Technical Service Bulletin

26 Chirping noise from rear of vehicle

26 17 31 2047565/1 April 18, 2017.

Model(s)	Year	VIN Range	Vehicle-Specific Equipment
R8	2016 - 2017	900001 - 904259	Not Applicable

Figure 3. Washer.

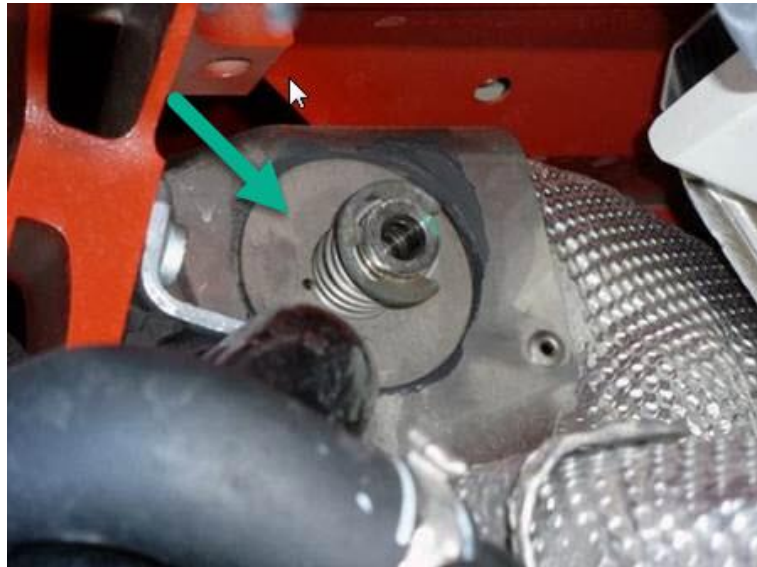
The graphite-coated side of the washer must face the heat shield (Figure 3).
